ONE LINE DIAGRAM REACTOR BLDG
480V MCC111,114,117,119,11X,11Y&11Z
SHOREHAM NUCLEAR POWER STATION
UNIT 1
LONG ISLAND LIGHTING COMPANY
STONE & WEBSTER ENGINEERING CORPORATION
BOSTON, MASS.
L100
DRAWING
NUMBER M-11094-12

Shoreham Outstanding SER Issue #3

Shoreham Outstanding SER Issue #5
LOCA Loadings on Reactor Vessel Supports and Internals

TABLE 223.90-1
PLANT SAFE SHUTDOWN
SELECTION OF SHUTDOWN SYSTEMS

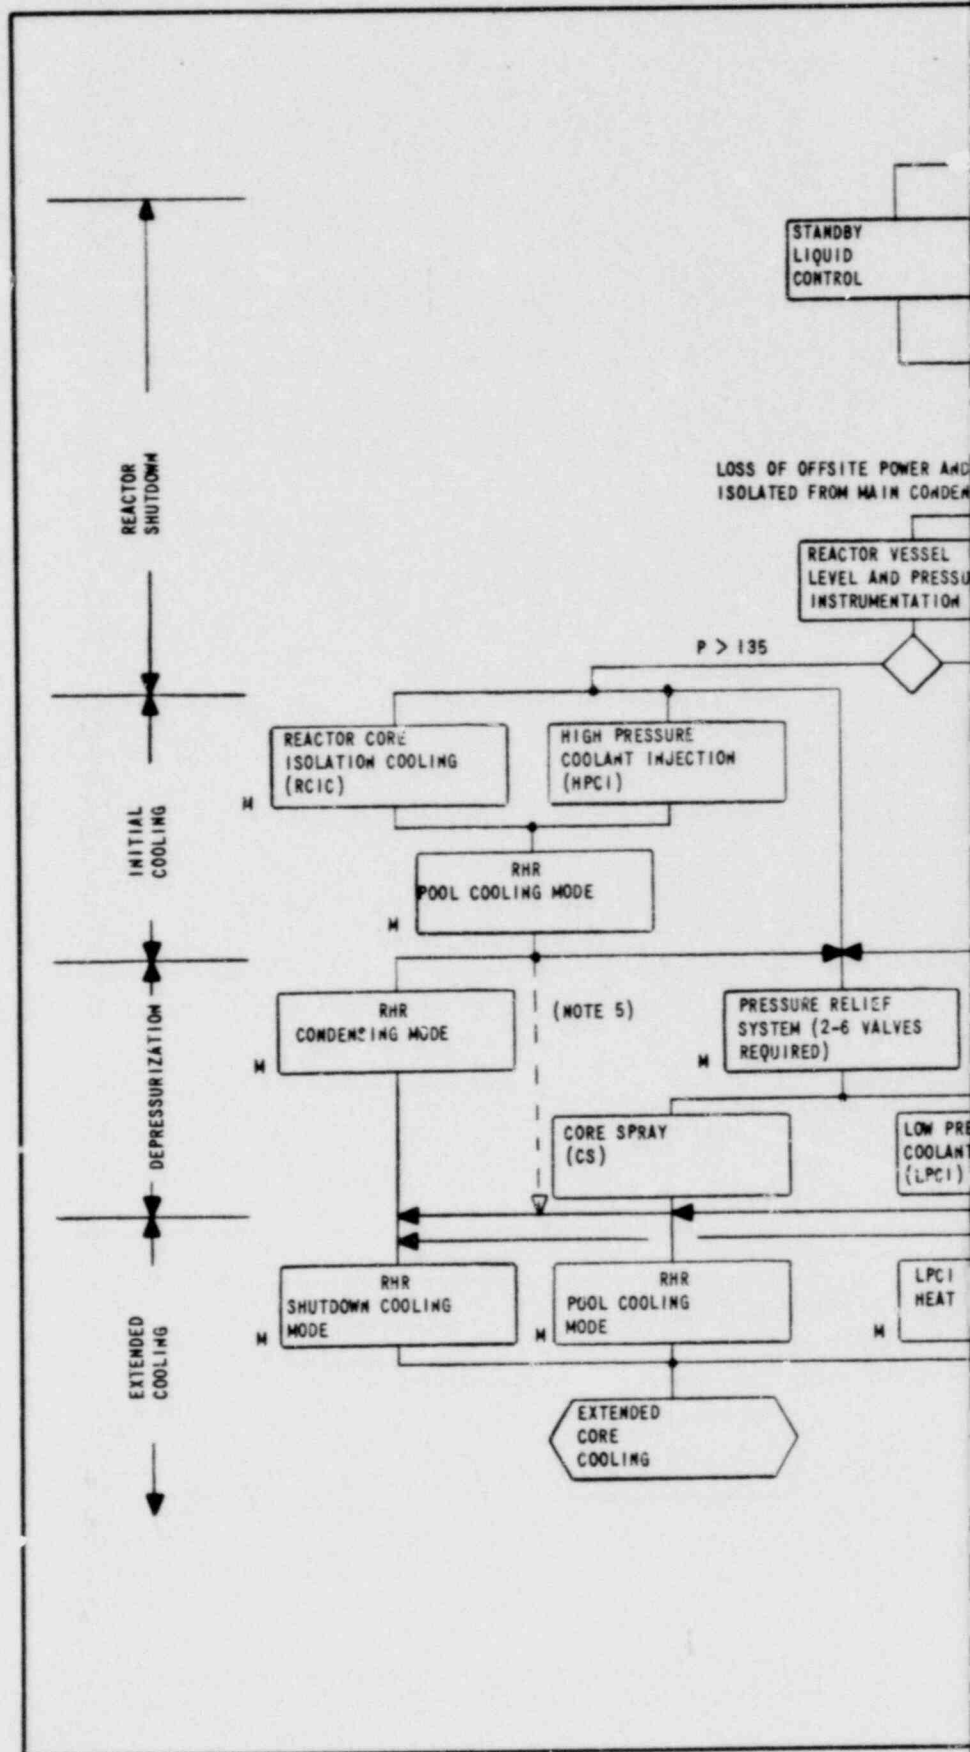
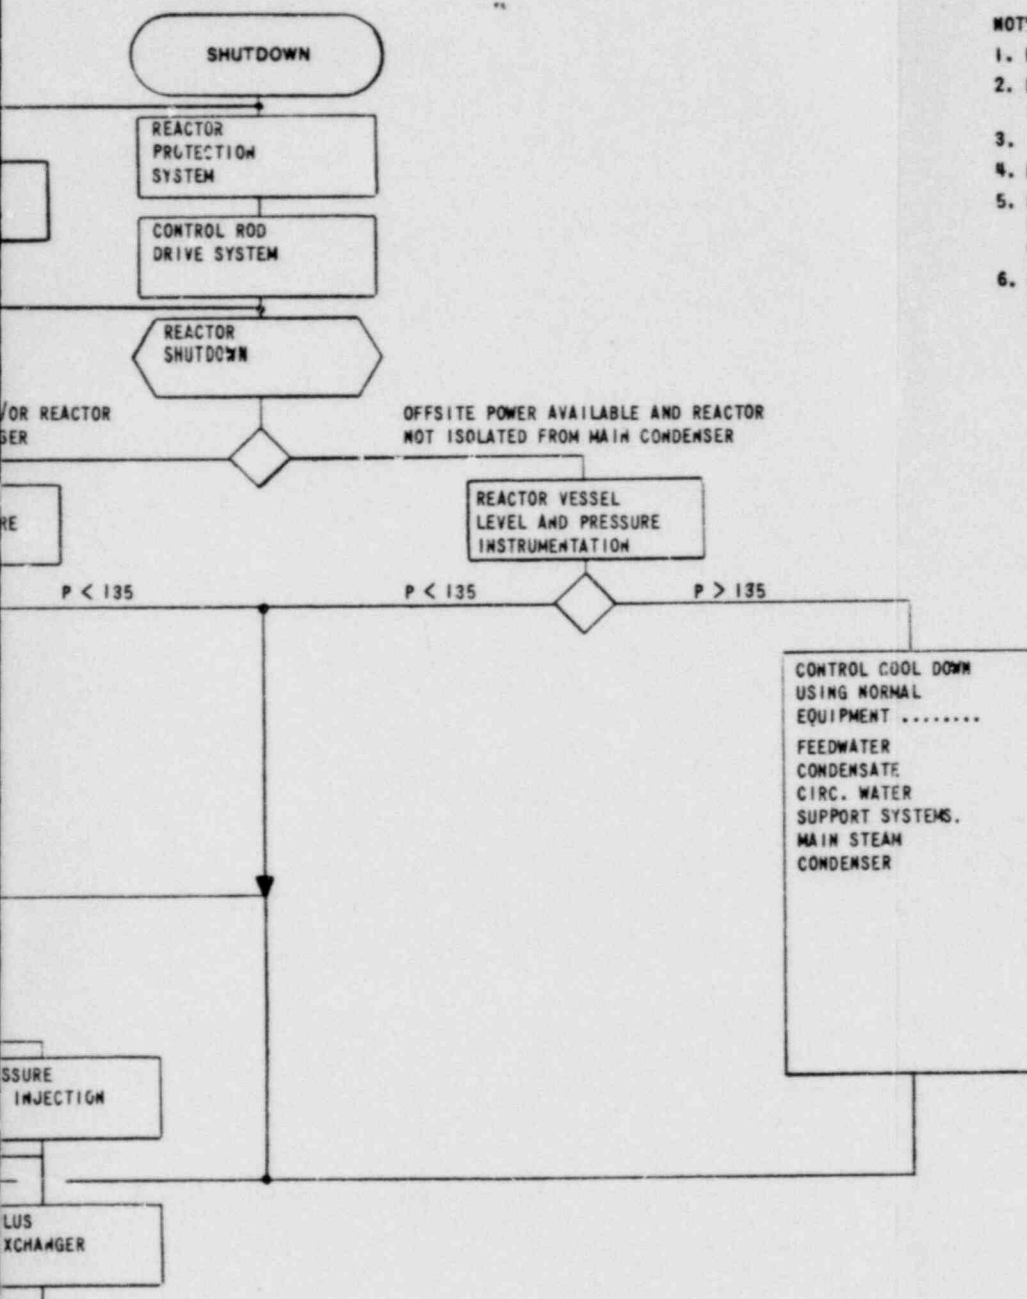
Provide a response to IE Bulletin 79-27, dated November 11, 1979, for Shoreham.

On Shoreham, a protection sequence for shutdown was developed showing the different paths that could be used to achieve cold shutdown. (Figure 223.90-1) Based on the sequence, it was determined that only Class 1E systems are necessary to achieve cold shutdown. Tables 223.90-1 and 2 list the Class 1E systems and components with power sources that could be used to achieve cold shutdown. Also, attached are Shoreham's Class 1E one-line diagrams.

1. RCIC IS AUTO START, MANUAL RESET.
2. RHR CONDENSING MODE REQUIRES NON-SAFETY INSTRUMENT AIR.
3. INSTRUMENTATION NOT SHOWN.
4. M - MANUAL.
5. NO FORCED COOLDOWN CAPABILITY THIS PATH HOWEVER PLANT REMAINS SAFE IN HOT SHUTDOWN CONDITION AND WILL EVENTUALLY DEPRESSURIZE.
6. ADDITIONAL FLEXIBILITY EXISTS IN THAT PATHS OF MANY OPERATIONS MAY BE RETRACED.
